## Access Compliance Report Public Rights-of-Way (Curb Ramps)

Intersection ID: 10035551Main Street: REA\_RDCross Street: N/ALocation:NWADA ID: 03E57D4D1B00Ramp Type: PerpDiagInitial Pass/Fail: FailOverall Compliance: NoSeverity Score:10

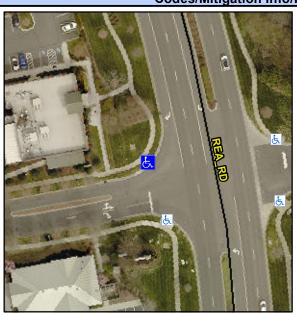
R304.5.1, R304.5.3

Field Measurements/Component Compliance					
Compliance Description		Data	Compliance Description		Data
N/A	Ramp Length (in)	72.0	Yes	Ramp Slope (%)	8.0
No	Ramp Width (in)	41.0	No	Ramp XSlope (%)	4.4
N/A	Flare Type LT	N/A	N/A	Flare Type RT	N/A
N/A	Flare Slope LT (%)	N/A	N/A	Flare Slope RT (%)	N/A
N/A	Flare Traversable LT?	N/A	N/A	Flare Traversable RT?	N/A
N/A	Landing Length (in)	N/A	N/A	DWS Provided?	N/A
N/A	Landing Width (in)	N/A	N/A	DWS Contrast?	N/A
N/A	Landing Slope (%)	N/A	N/A	DWS Length (in)	N/A
N/A	Landing X Slope (%)	N/A	N/A	DWS Full Width?	N/A
N/A	Landing Curb? (Y/N)	N/A	N/A	DWS Offset (in)	N/A
N/A	Shared Landing?	N/A			
N/A	Gutter Ponding?	N/A	N/A	Gutter Slope (%)	N/A
N/A	Gutter Lip Ht (in)	1.0	N/A	Gutter X Slope (%)	N/A
N/A	Painted X Walk1?	No	N/A	Painted X Walk2?	No
	X Walk 1 Direction	To S		X Walk 2 Direction	To E
N/A	X Walk 1 Width (in)	N/A	N/A	X Walk 2 Width (in)	N/A
	X Walk 1 Slope (%)	0.5		X Walk 2 Slope (%)	2.1

X Walk 1 X Slope (%)	3.2		X Walk 2 X Slope (%)	0.0
N/A	Ramp inside XWalk1?	N/A	N/A	Ramp inside XWalk2?	N/A
	Road Slope (%)	2.1	N/A	Clear Space?	N/A
	Road X Slope (%)	1.7	N/A	Clear Space to XWalk (in)	N/A
N/A	Any Obstructions?	N/A	N/A	Storm Grate/Utility Hazard?	N/A
	Obstruction Type		l	Storm Grate/Utility Type	
		N/A			N/A
			Yes	Surface Condition? (G/P)	Good

Remove & Replace Curb Ramp With Two New Directional Ramps or Equivalent.
